BRUNSWICK STEAM ELECTRIC PLANT, UNIT NOS. 1 AND 2
DOCKET NOS. 50-325 AND 50-324
LICENSE NOS. DPR-71 AND DPR-62
SUPPLEMENTAL INFORMATION -
TMI ITEMS I.A.2.1 & II.B.4

CAROLINA POWER & LIGHT COMPANY'S (CP&L) RESPONSE
TO UPGRADED SRO AND RO TRAINING AND TRAINING FOR
MITIGATING CORE DAMAGE - NRC REQUEST FOR
ADDITIONAL INFORMATION (APRIL 2, 1982)

Figure 1

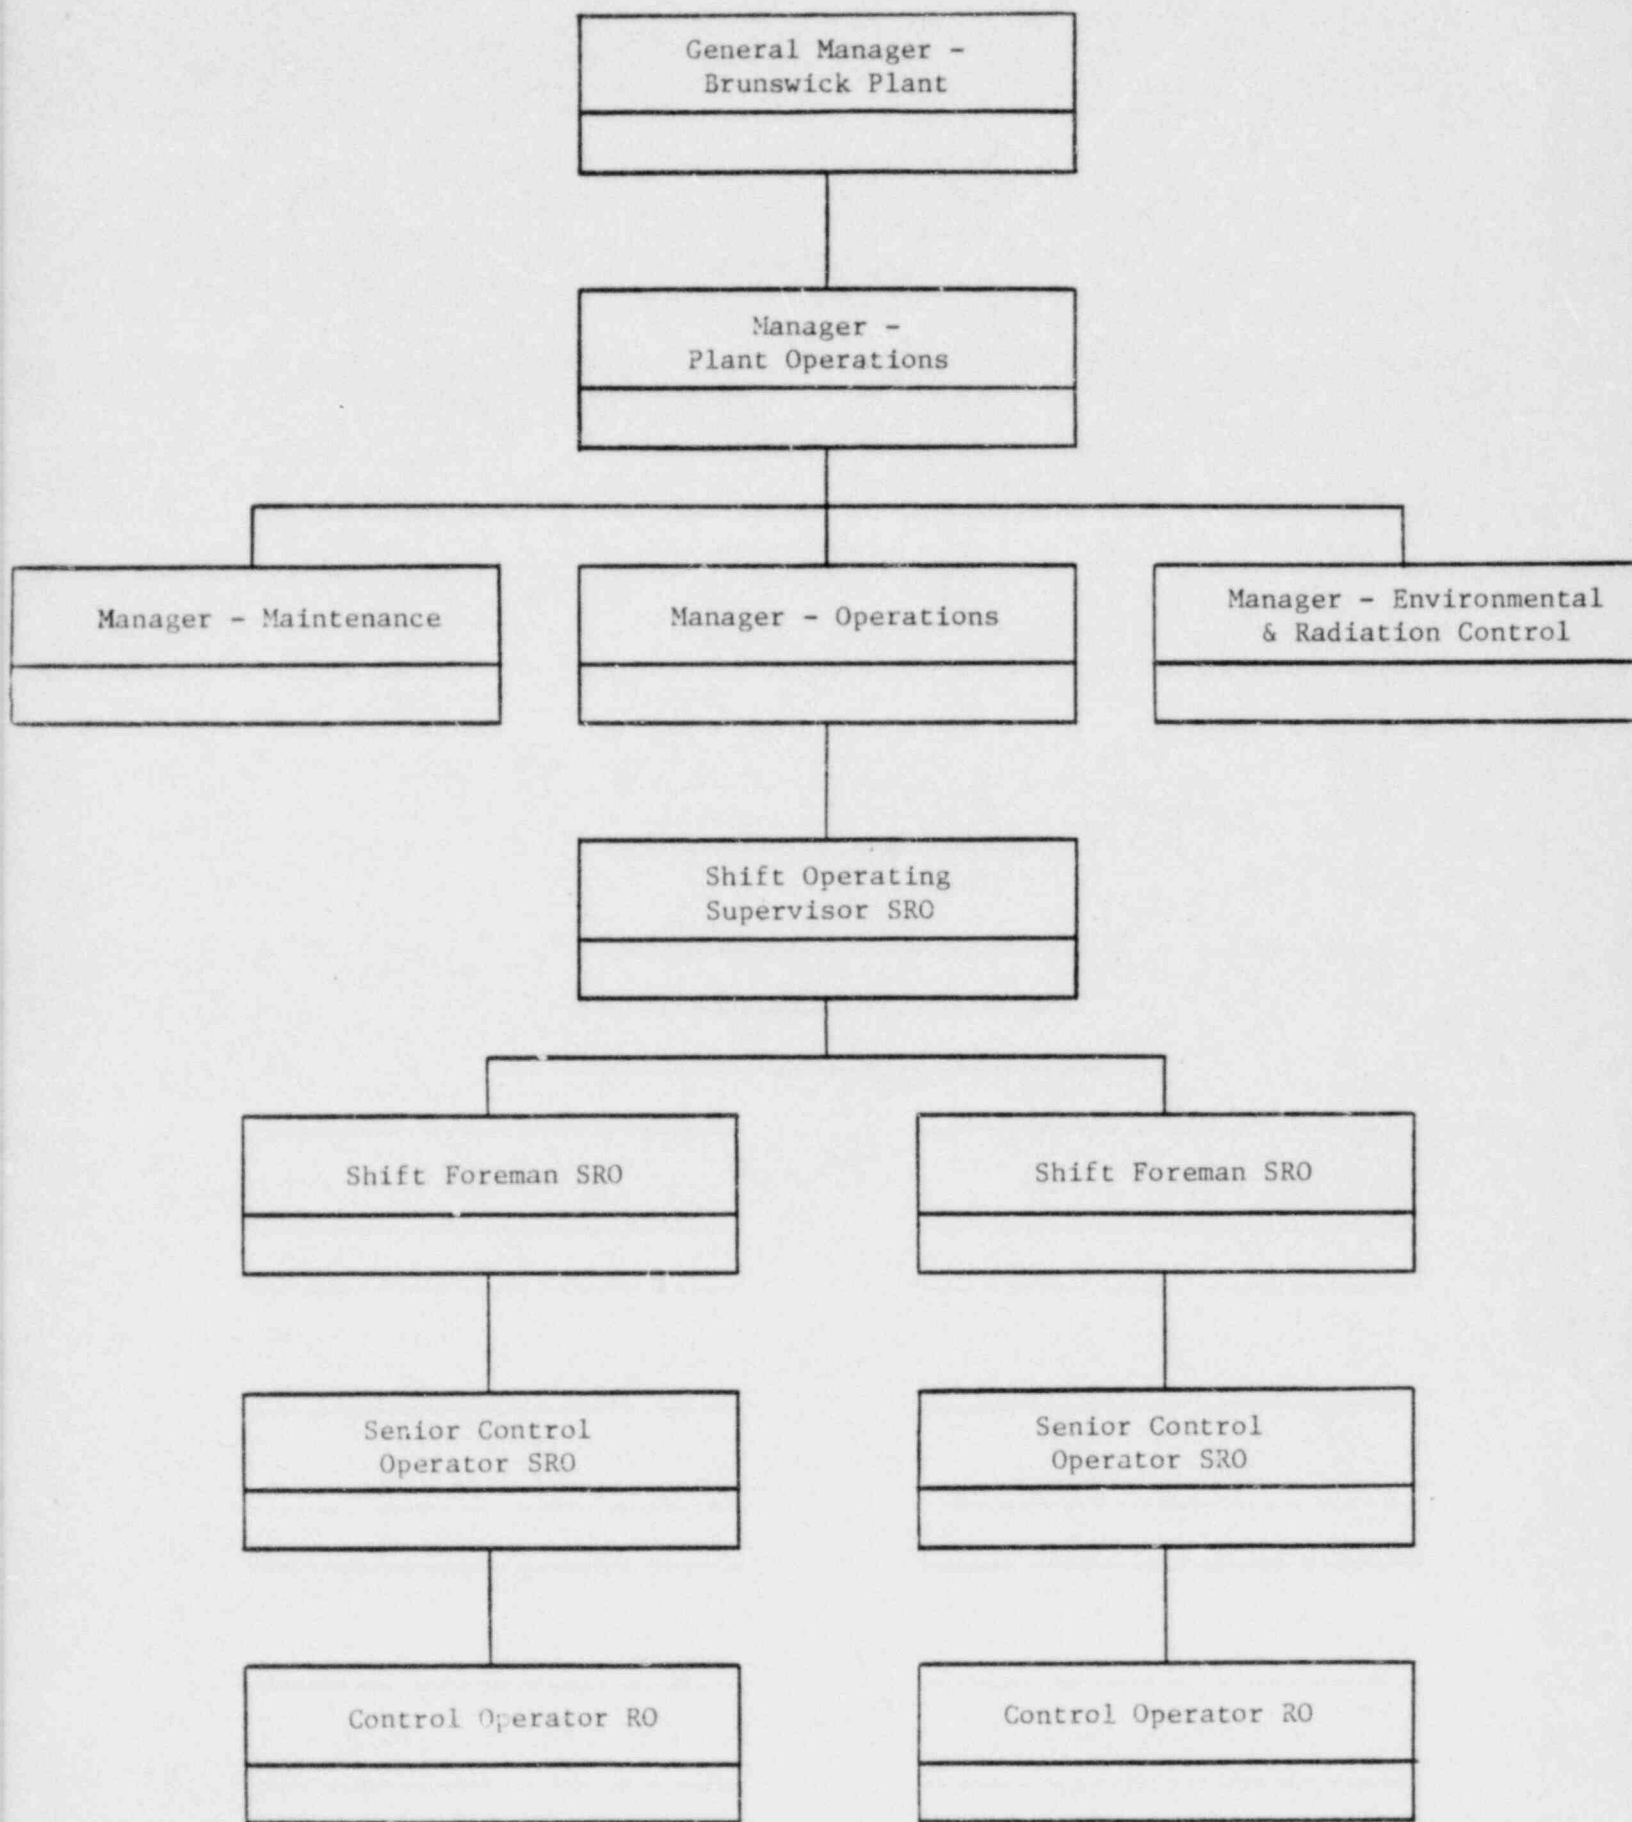
Are the lectures and quizzes on the subject of accident mitigation given to shift technical advisors and operating personnel from plant manager through the operations chain to the licensed operators? If they are, would you please provide the titles of the people who are trained and an organization chart which illustrates their position in the operations chain?

Figure 1 indicates management positions in the operating chain that received the training.
